INDEPENDENT EXPERT ADVISORY PANEL FOR MINING

**DENDROBIUM COAL MINE
LONGWALLS 24 to 29
SUBSIDENCE MANAGEMENT PLAN**

24 April 2026

Report No: IEAPM 202604-01

Figure 3: Groundwater model extents (Figure 4.2 from Watershed HydroGeo 2025)

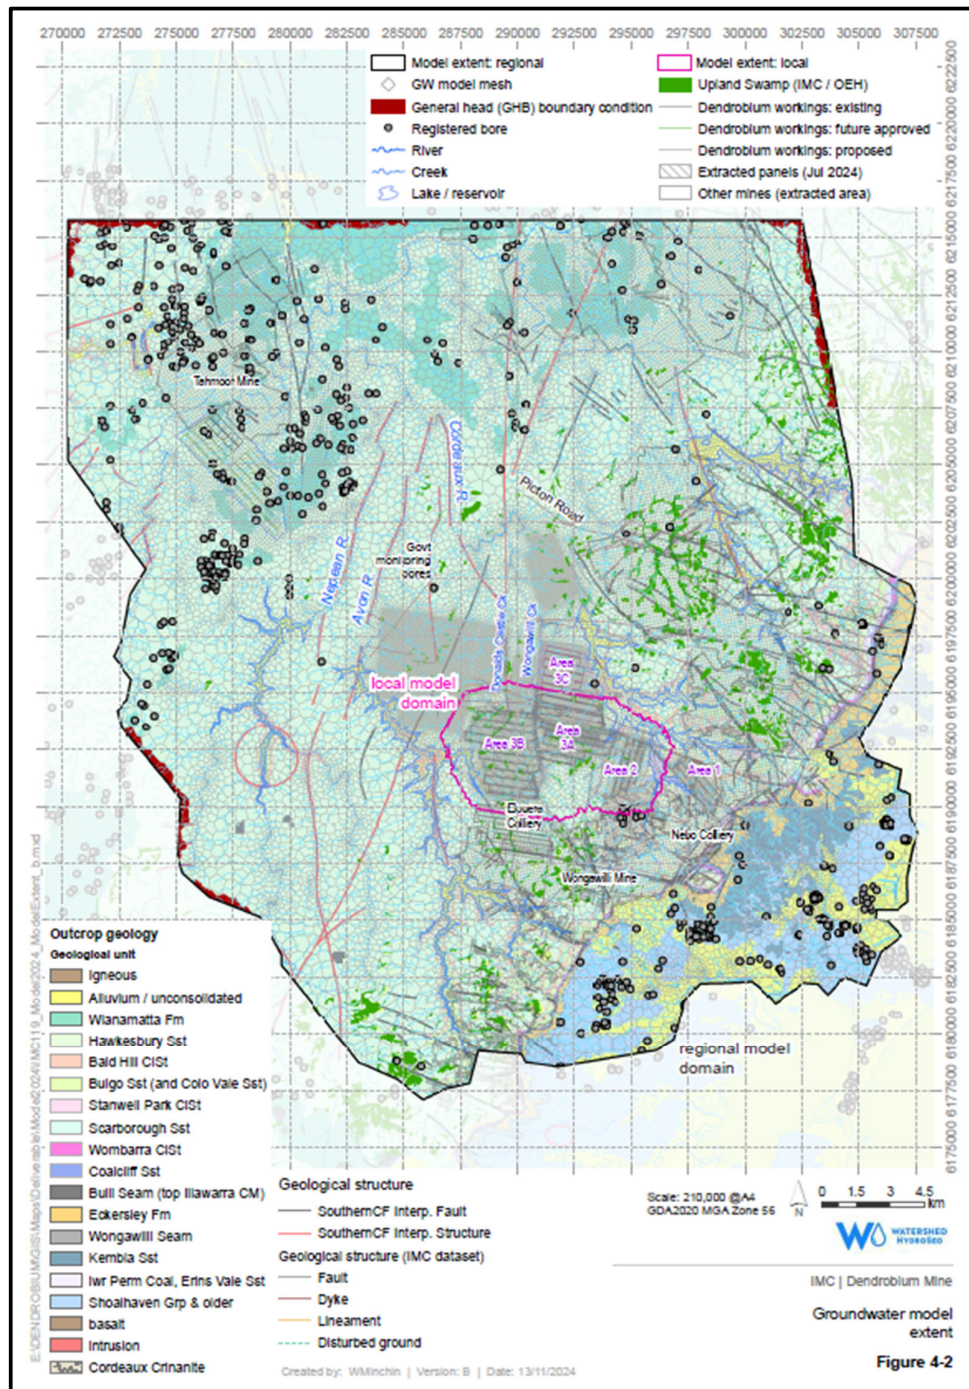
The Panel supports this approach of better defining model parameters and processes on a local scale (where there is sufficient geological and hydrogeological data) to better inform the regional model. For future regional modelling, the Panel also supports the recommendation (provided run times are manageable) that:

A model mesh be developed that is smaller than the current 'regional' model, and with coarser cells away from Dendrobium, and potentially removing or reducing the areas of 'square' mesh around Dendrobium which recent experience suggests results in unnecessary additional model cells.

This approach would remove the need for the paired local-regional model approach and the necessity to expand the local-scale model, by allowing calibration and prediction with a single (more robust) groundwater model. Watershed HydroGeo, 2025 recommends that the regional model be reviewed and verified again in 2028 (if it has not occurred before), after more groundwater data has been gathered in Area 3C. The Panel recommends that the next regional model update occur before the completion of LW 23 which is expected to finish in September 2027 (i.e. before the commencement of LWs 24-29).

Figure 4: Maximum predicted drawdown in the Lower Hawkesbury Sandstone (Figure 6.3 from Watershed HydroGeo 2025)

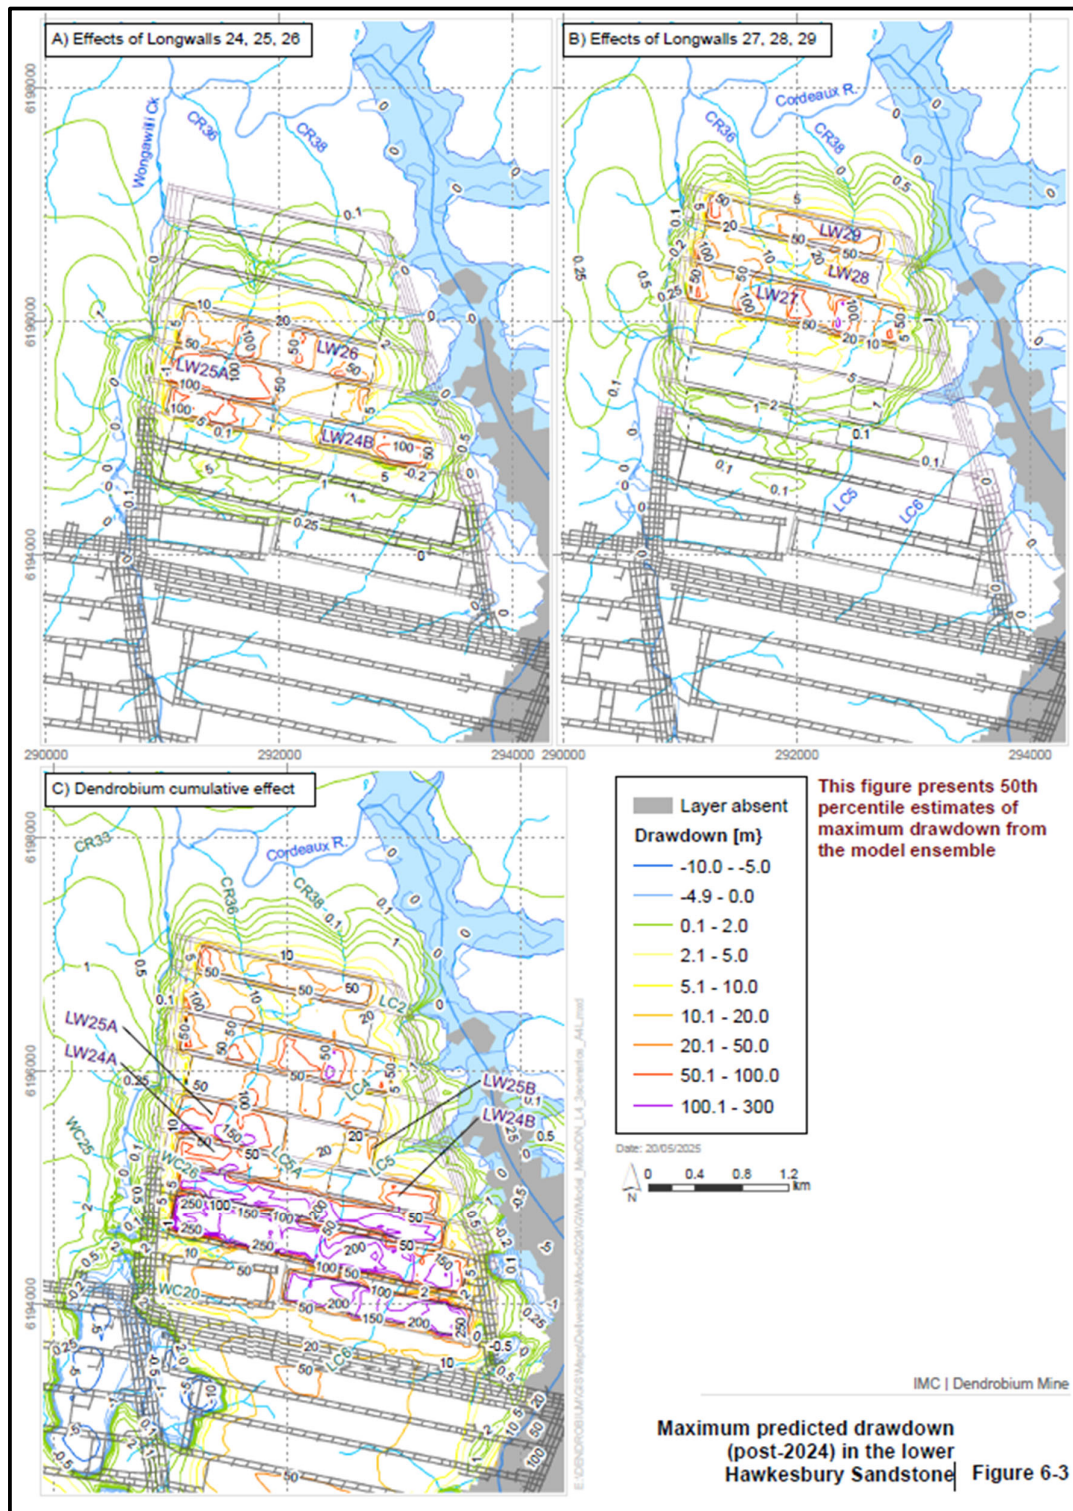
The maximum predicted drawdown (50th percentile estimate) in the lower Hawkesbury Sandstone (model layer 4) is reproduced in Figure 4.

All these plots predict significant drawdown and effective desaturation of the lower Hawkesbury Sandstone above all longwalls with the cone of depression extending east (to the reservoir) and west (to and just beyond Wongawilli Creek), although predicted drawdowns are typically less than one metre in the area beyond the footprint of each longwall.

Figure 5: Maximum predicted drawdown in various model layers (part of Figure M1 from Appendix L of Watershed HydroGeo 2025)

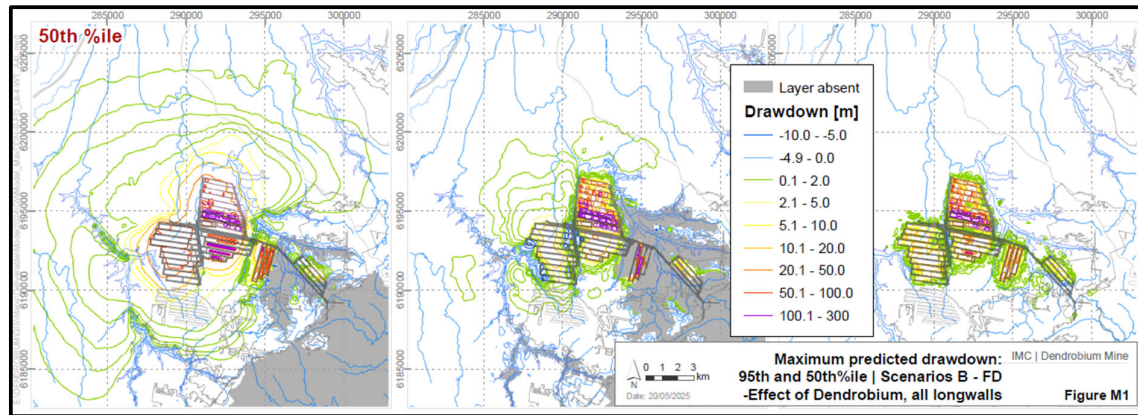
Similarly for the underlying Bulgo Sandstone (model layers 6 and 7) which is the predominant geological unit in contact with the stored water in Cordeaux Reservoir, the drawdowns are extensive. The comparison of the maximum predicted drawdowns (50th percentile estimate) in the lower Bulgo Sandstone (model layer 6 - left), lower Hawkesbury Sandstone (model layer 4 - centre), and the upper Hawkesbury Sandstone (water table - right) is reproduced in Figure 5.

Drawdowns of between 10 and 50 m are predicted in the lower Bulgo Sandstone in the immediate eastern, northern and western areas adjacent to LWs 24-29.

The Panel concludes that the updated modelling is sufficient to progress an approval for the SMP, however further model improvements are required to more accurately predict the full extent of groundwater drawdowns, and to quantify surface water seepage losses. The Panel is concerned that the TVM approach that previously applied increases in Kh in the off-goaf area surrounding each longwall has been removed in the current modelling simulations and both surface water and groundwater impacts may be underestimated.
